UNITED STATES
 NUCLEAR REGULATORY COMMISSION
 WASHINGTON, D. C. 20555

MAR 2 1985

LICENSEE: LOUISIANA POWER AND LIGHT COMPANY
 FACILITY: WATERFORD 3
 SUBJECT: BASEMAT - MEETING SUMMARY

PROGRAM
TO
PERFORM CONFIRMATORY ANALYSES
NUCLEAR PLANT ISLAND STRUCTURE BASEMAT
AT
WATERFORD STEAM ELECTRIC STATION-UNIT NO 3
LOUISIANA POWER AND LIGHT COMPANY

FIGURE 1

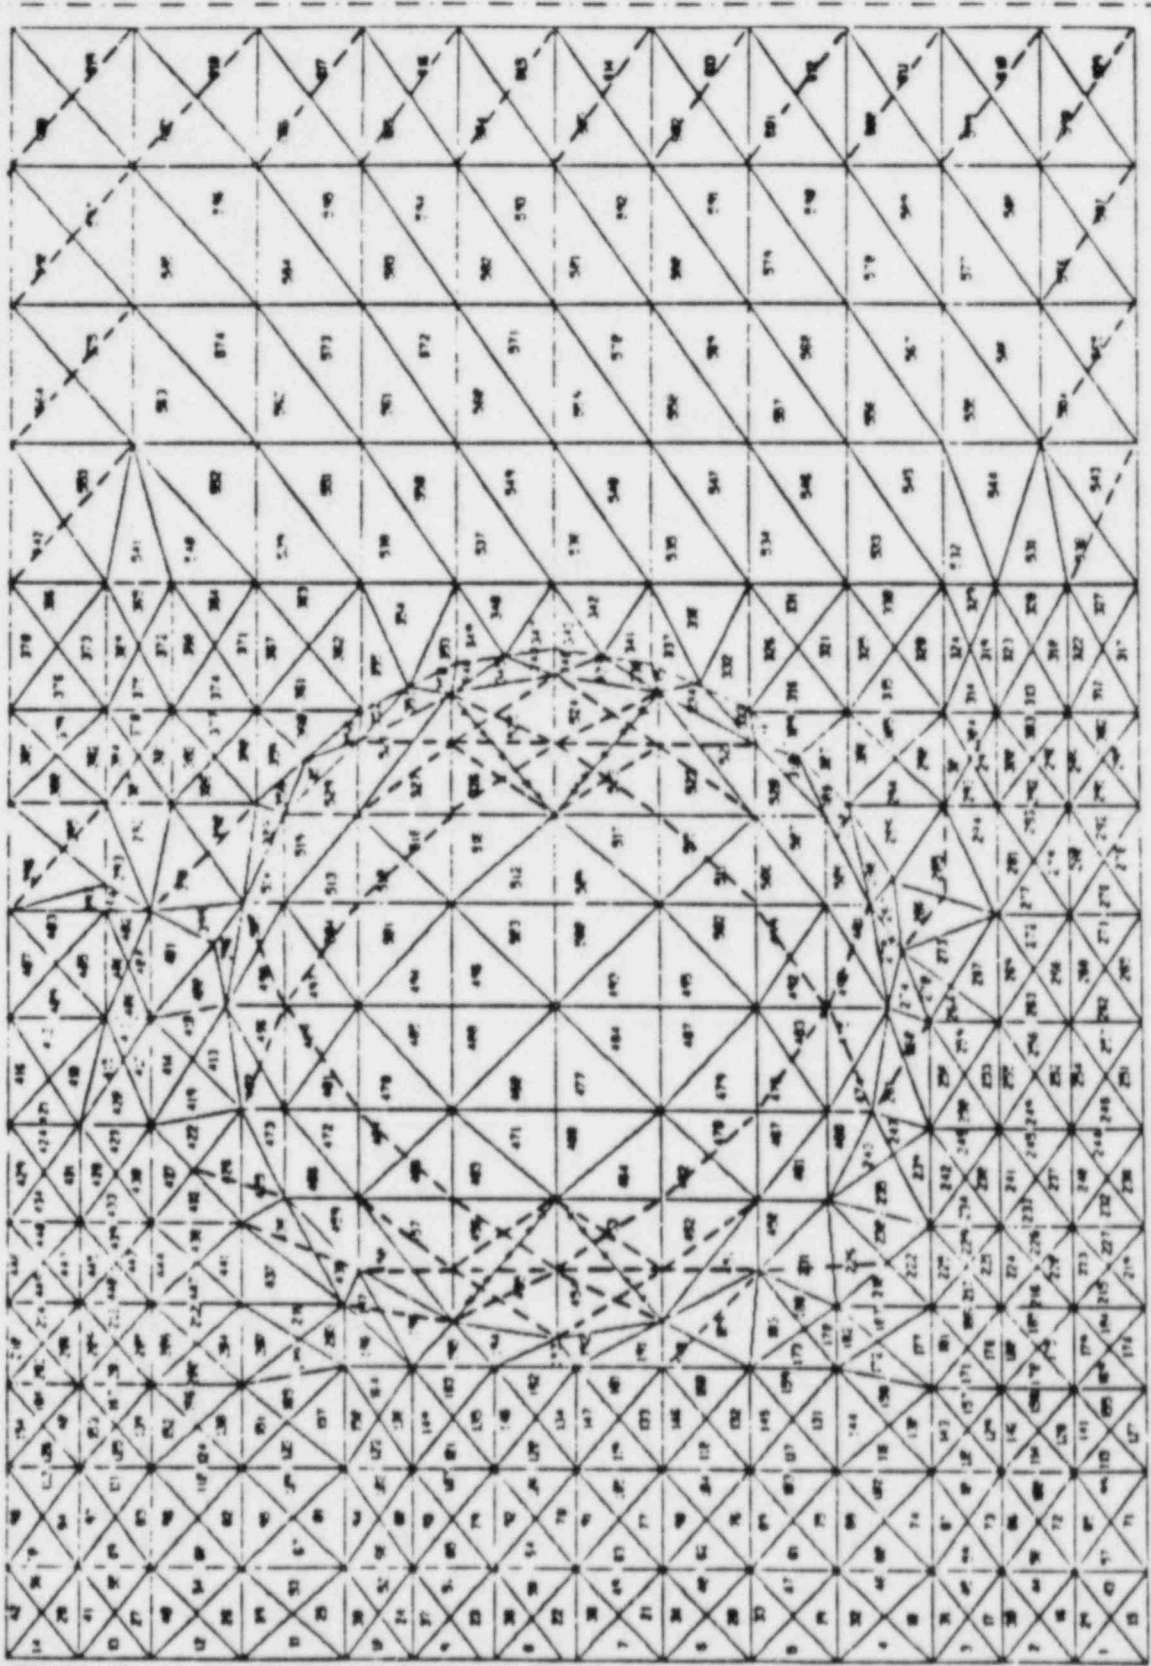
In addition, the staff felt that the finite element mesh, as presented at the meeting, required additional modification to further improve the fineness of the grid.

The existing STARDYNE model of the basemat will be modified as necessary to incorporate the finer element sizes. The areas which will be modified are areas in the vicinity of the Reactor Shield Building wall and areas forming the junction between the exterior walls of the NPIS and the basemat. Figure 1 shows the proposed modifications to the basemat finite element model mesh.
